## RESPONSE TO REZONING CONDITIONS

Project Name: **201 W 2<sup>nd</sup> Ave**  
Project Address: 201 W 2<sup>nd</sup> Ave  
Type of Development: Multifamily Residential Development  
Architect: GBL Architects  
Client: Concord Pacific Development Inc.

REZONING SCHEME NORTH-SOUTH ELEVATIONS.

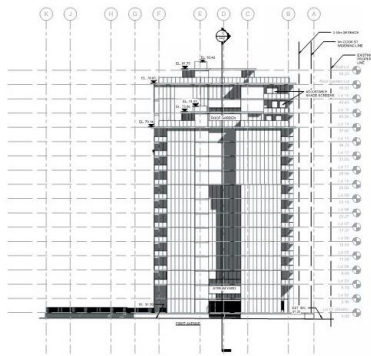
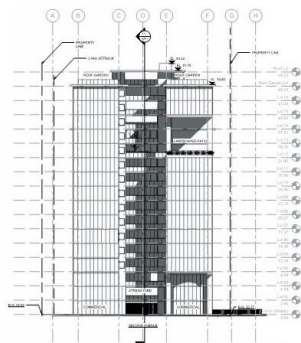
- (i) design development to the overall building to refine the massing and detailing and to further break down and slim the building scale;

Note to Applicant: This may be achieved by offsetting the slab forms on each side of the atrium. Consideration may also be given to hinging or angling the north from the south form

**Response:** The revised form proposes a slimmer building scale by eliminating the interior courtyard and having shallow units to the west. The refined detail on the elevation and the carving on several portions of the building provide additional quality to the elevations and help break down the massing. The building depth has decreased from 96ft to 67ft.

Current Scheme

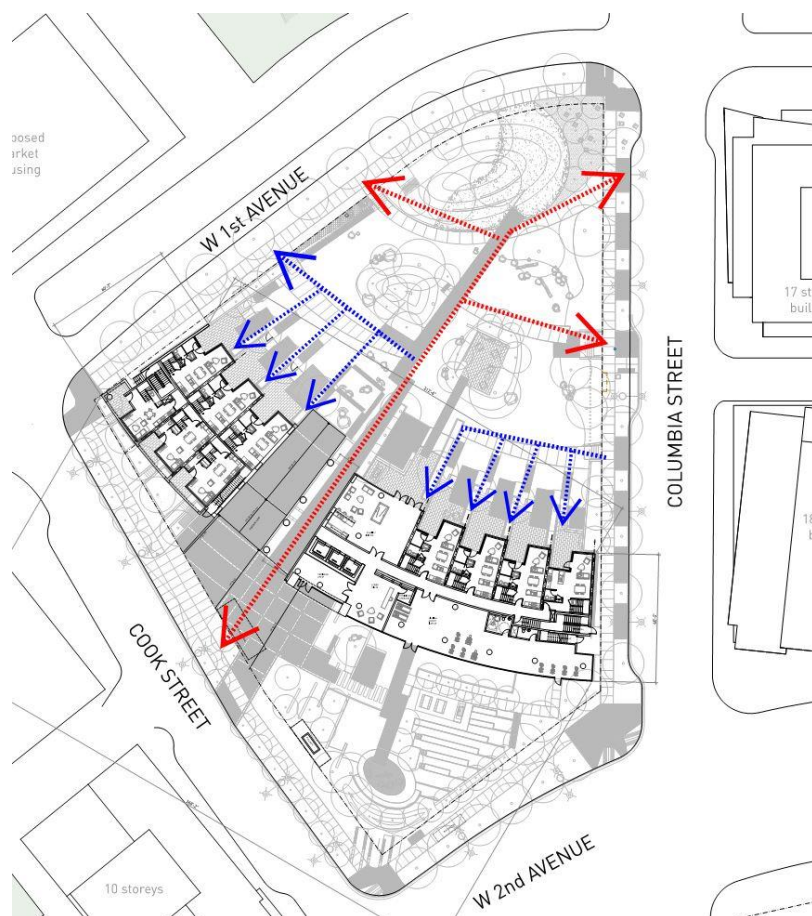
- (iii) provide a pedestrian mews along the east side of the building for use by the building residents;

**Response:** There are new pedestrian connections proposed in this scheme. The first one is a strong linear path through the building that runs diagonally from the west towards the north-east corner of the site. This path then diverts into two, connecting 1<sup>st</sup> Ave and Columbia Street.
